ADDENDUM NUMBER 1

ISSUE DATE: AUGUST 25, 2003

**PROJECT: ALLEN PARK TENNIS COURTS AND SIDEWALK IMPROVEMENTS -
JONESBORO, ARKANSAS.**

Attachment - A

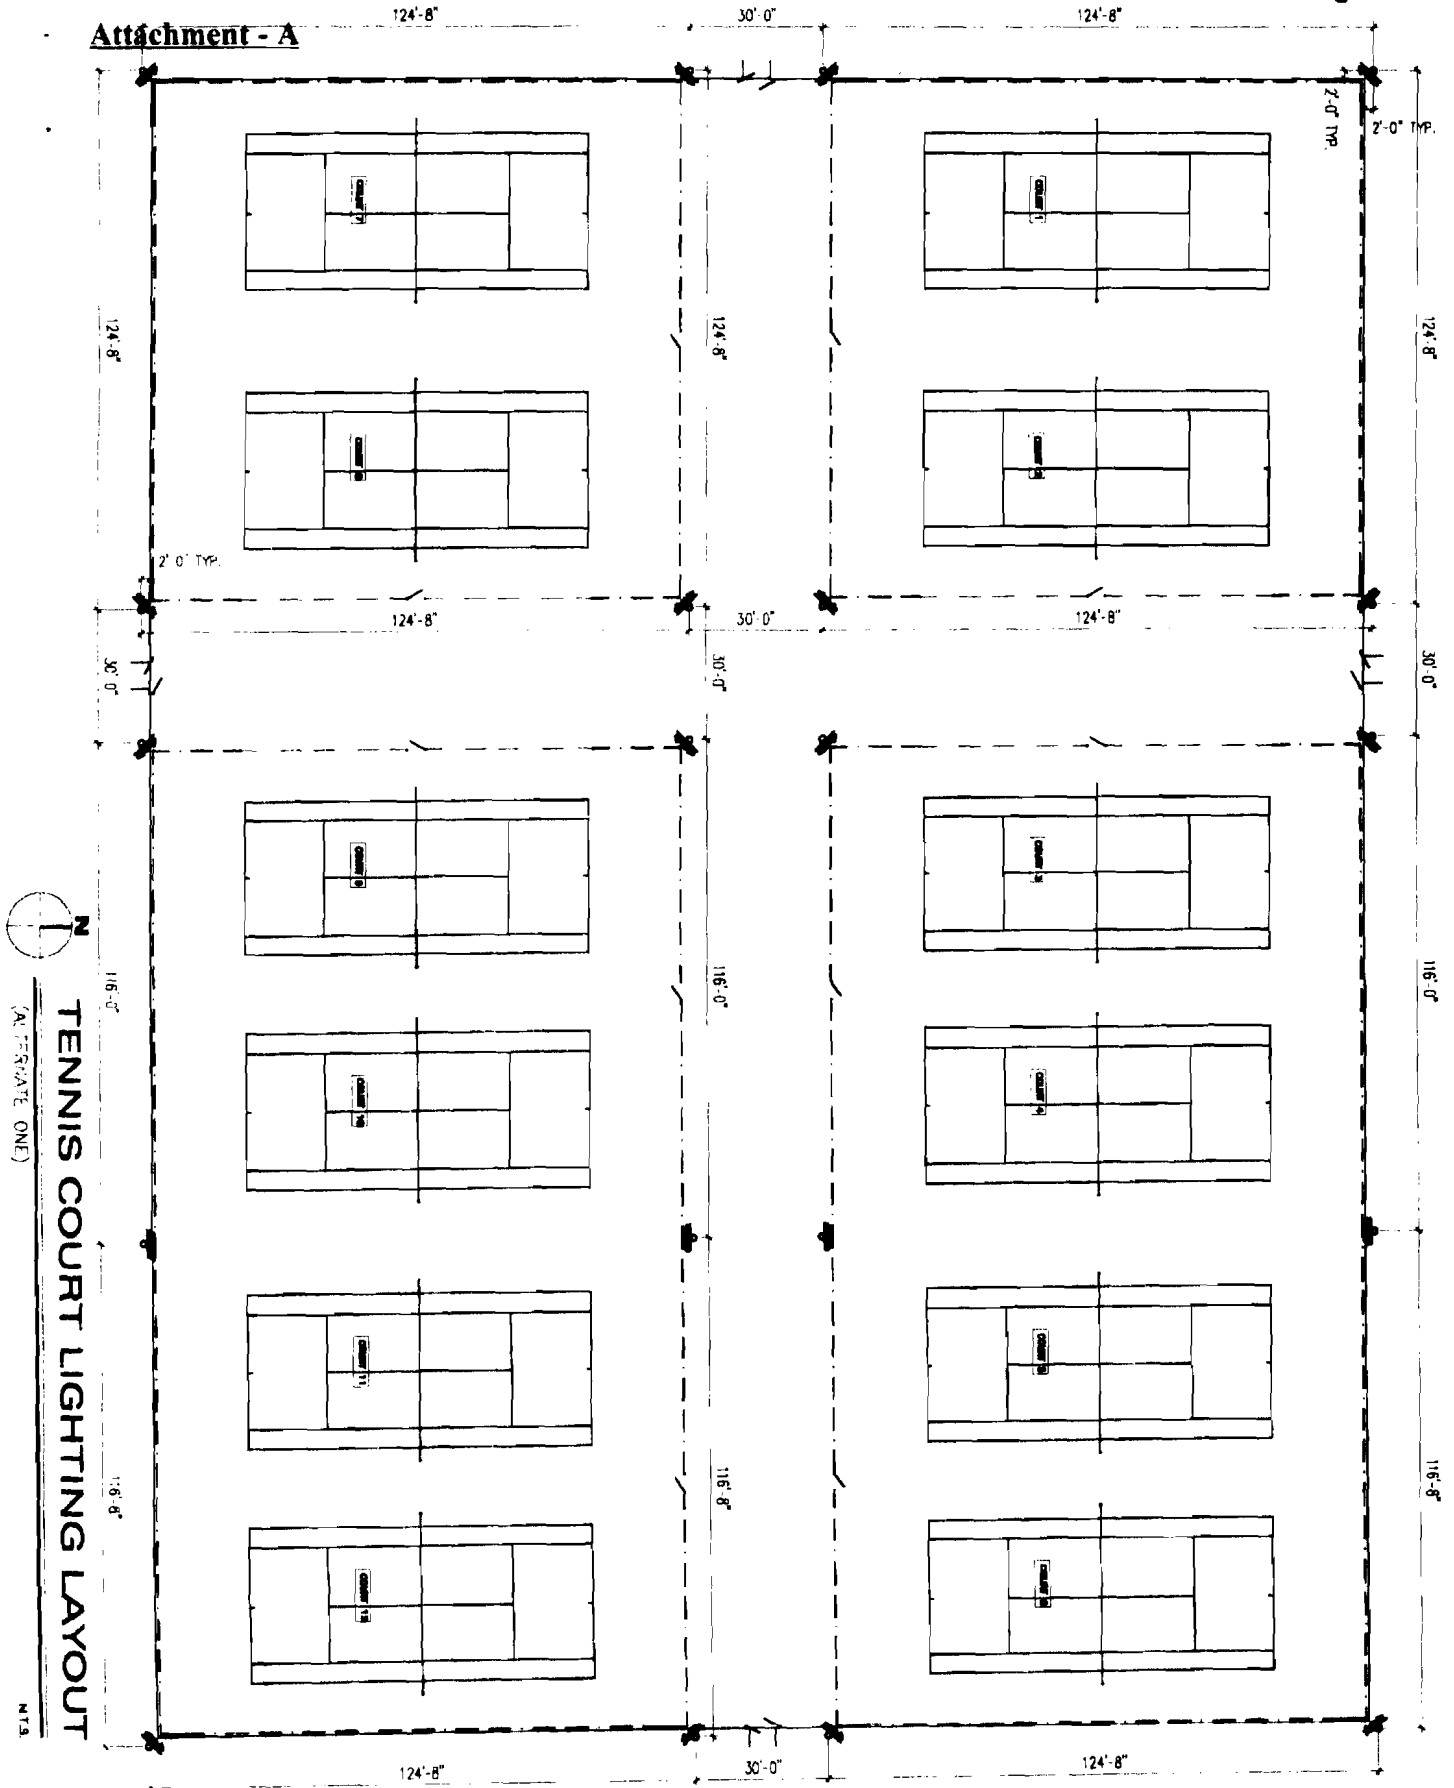
1. Refer to Light Pole Detail, Notes: Fixture shall be changed to General Electric Powerspot III.
2. See Attachment "A" for dimensional location of light poles for Alternate 1.
